Solder side Possible Block out Version 0.5a

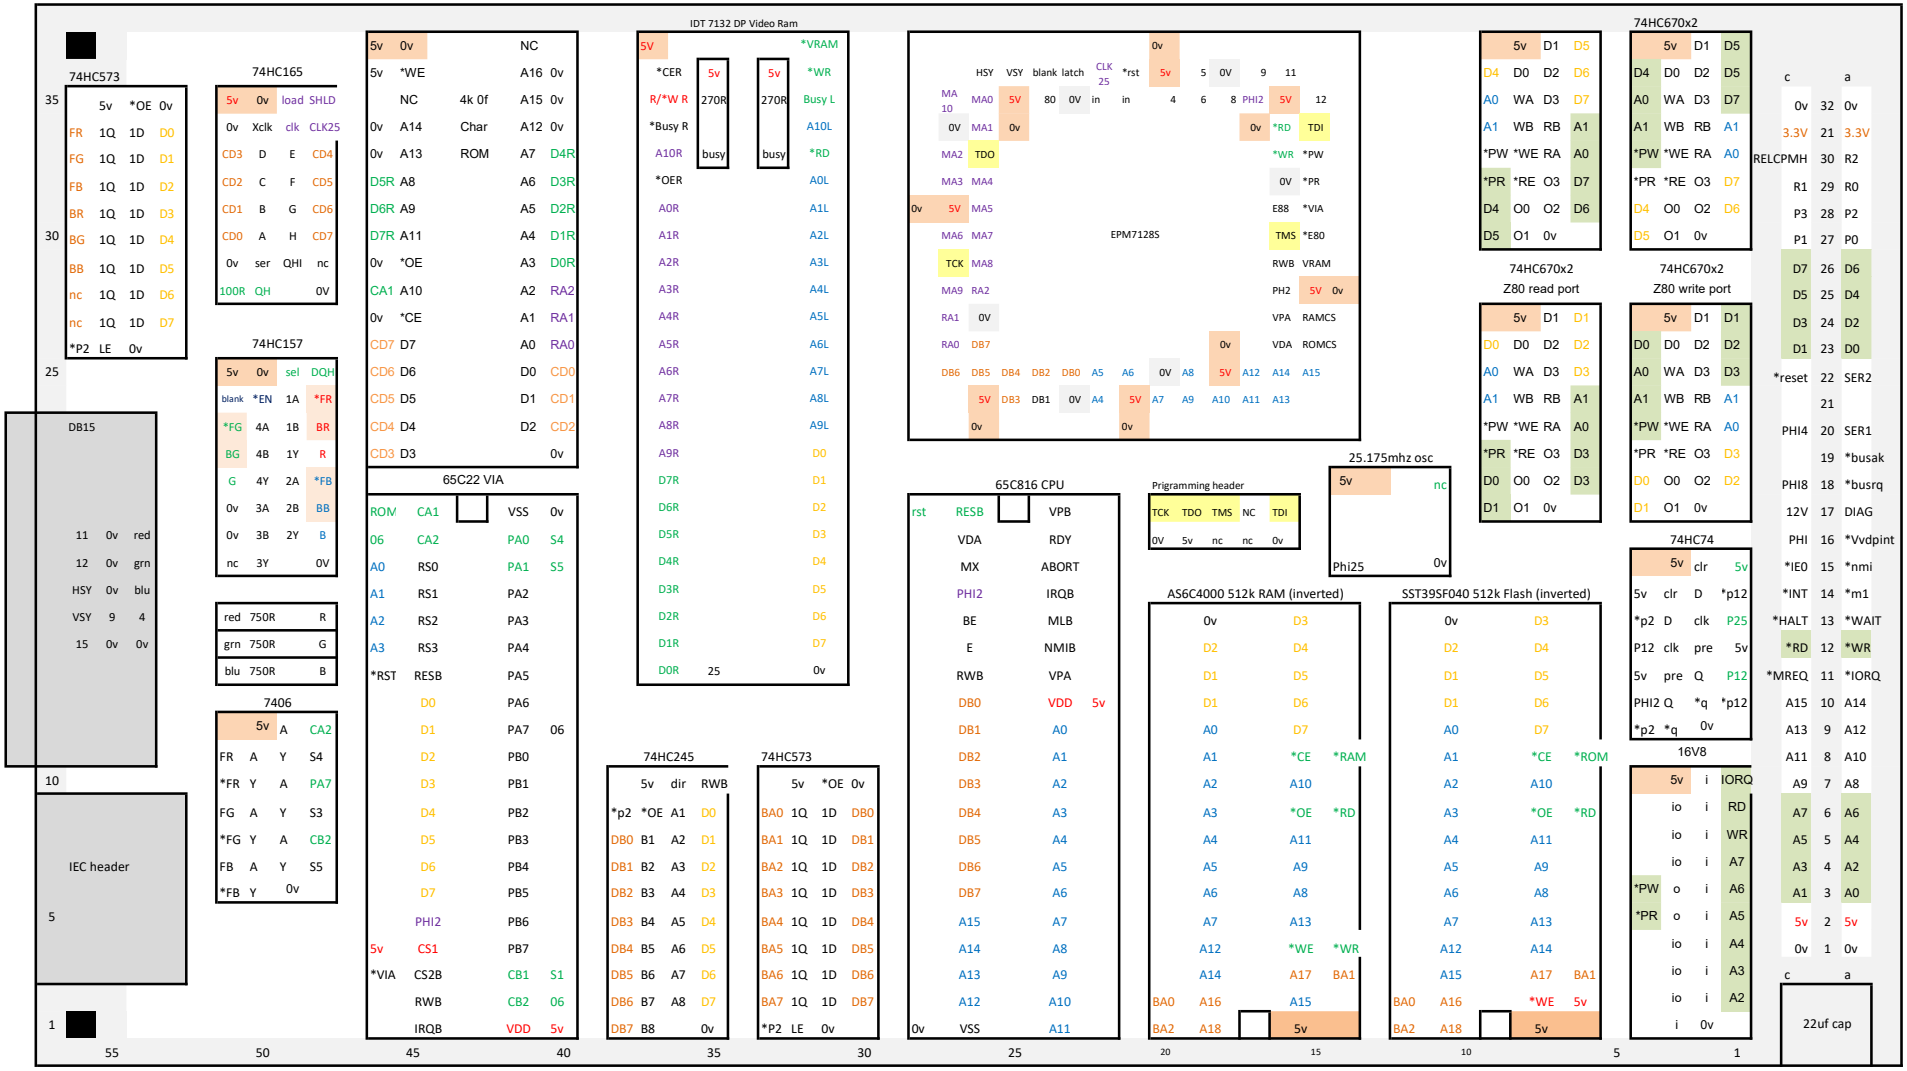
Ensure ram cannot be written to whebn PHI2 is low
